Addendum 1

Issue Date: October 9, 2018

Project Name: Regional District of Nanaimo
Coombs-Hilliers Firehall
Water Tanks Replacement

Project Number: 1019-001

**KIOSK ENCLOSURE
(FOR INFORMATION ONLY)**
VALID MANUFACTURING MODEL: DDSA6012048-170976
N.T.S.

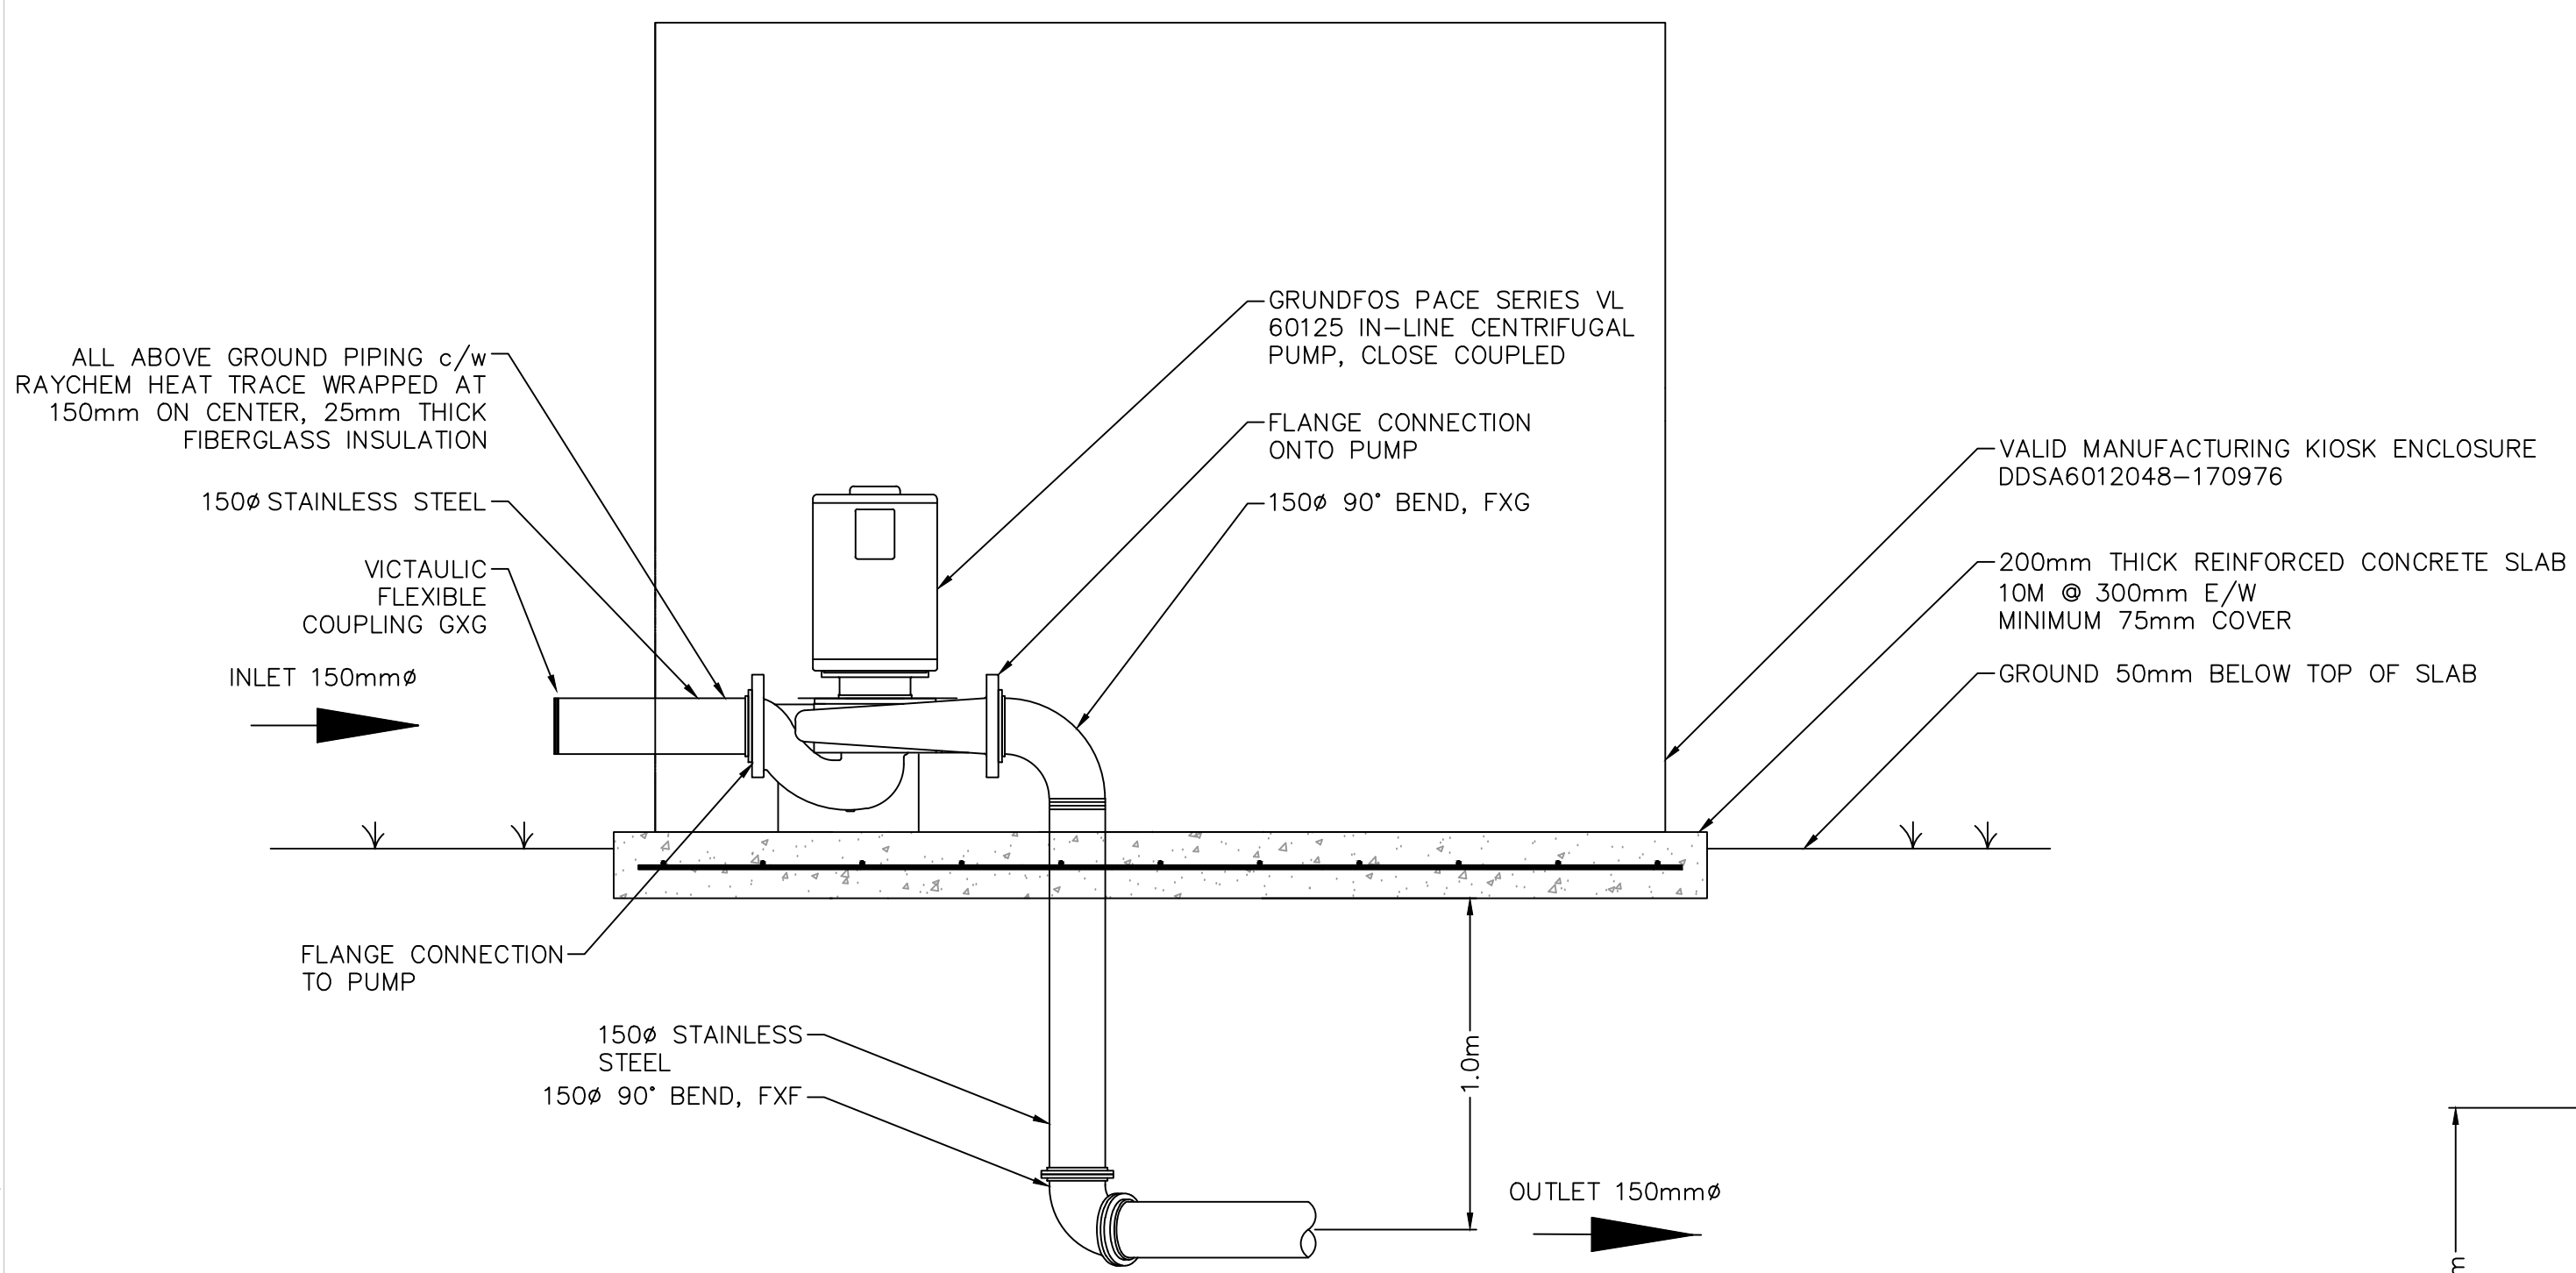
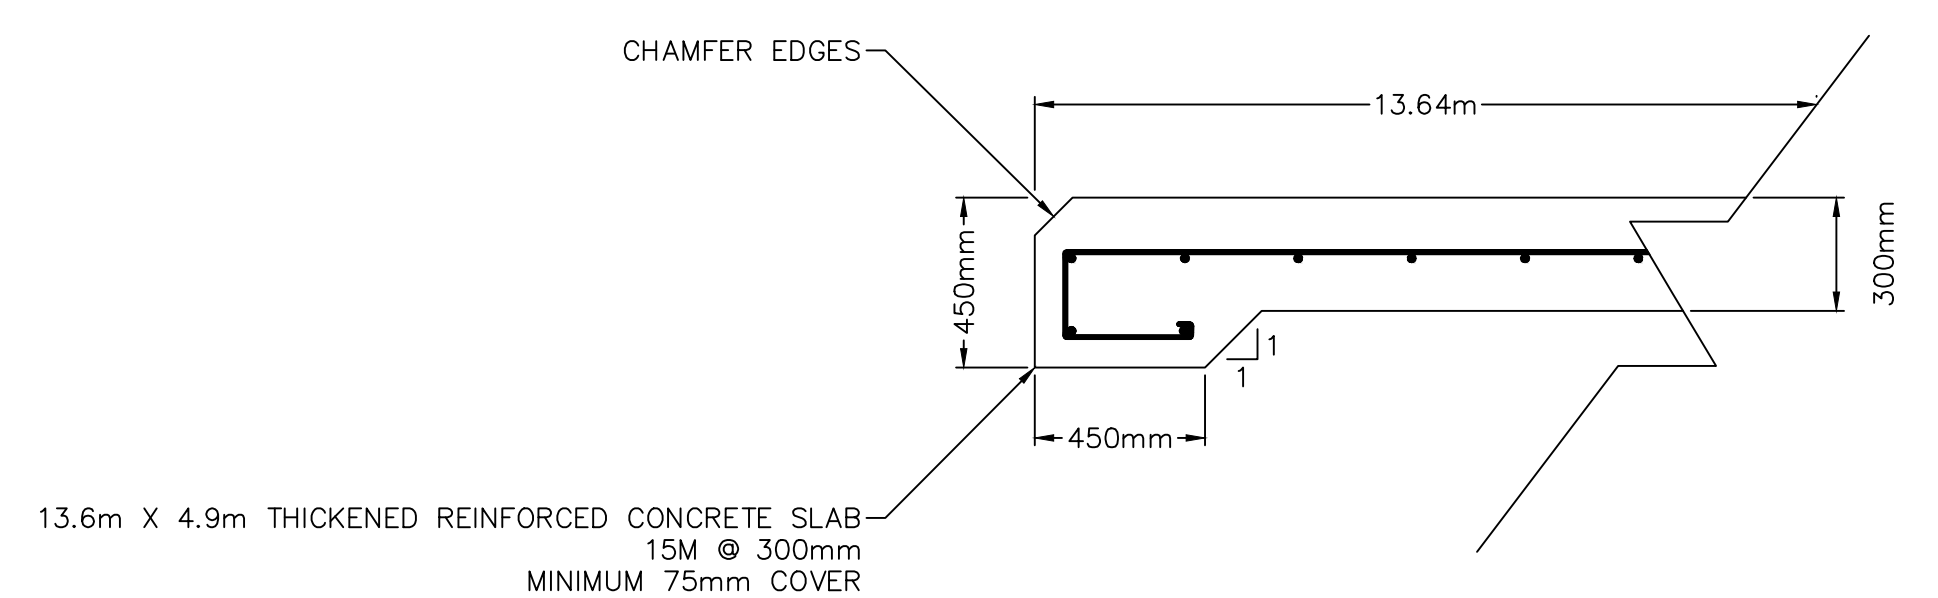
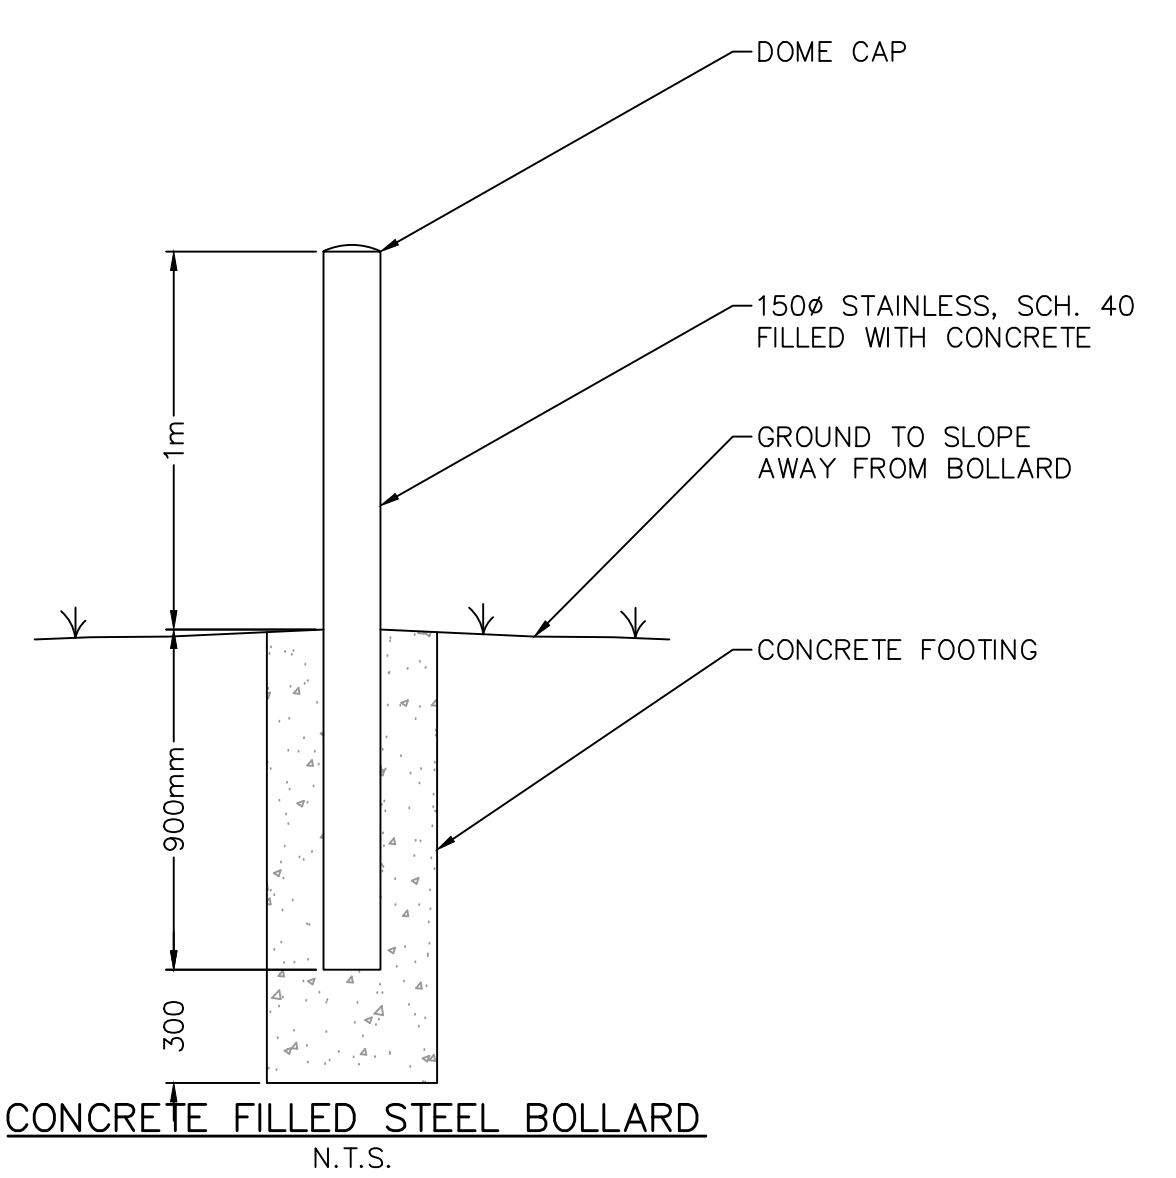
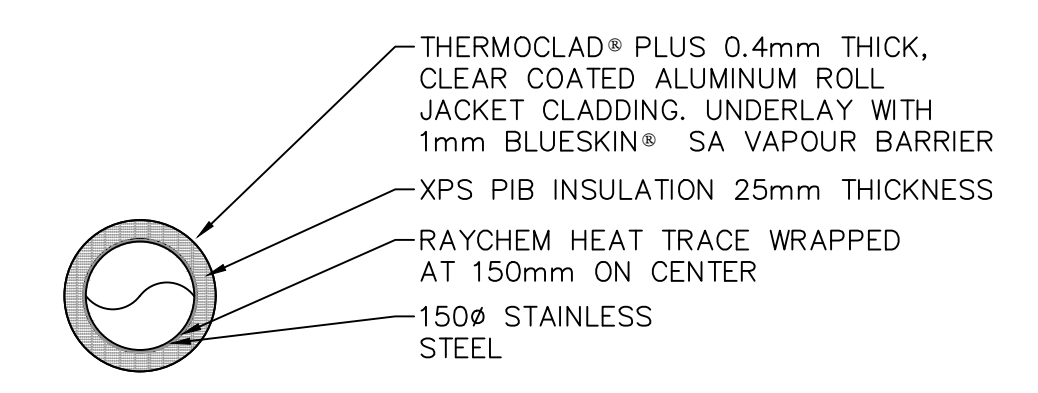
- Q1: What is the hydrant specification and bury requirements
- A1: Terminal City or AVK are acceptable. Hydrant feed line to have minimum 1m of cover.
- Q2: On the Tank Detail Item #8 please confirm if the quantity is 4 or 5?

- A2: Please see attached drawings
- Q3: On the Tank Detail Item #9 please confirm style and Spec?
- A3: Please see attached drawings
- Q4: Is bacteriological testing required for the water piping?

.1 Replace existing drawings with **Rev. F, dated 09OCT18 (attached)**
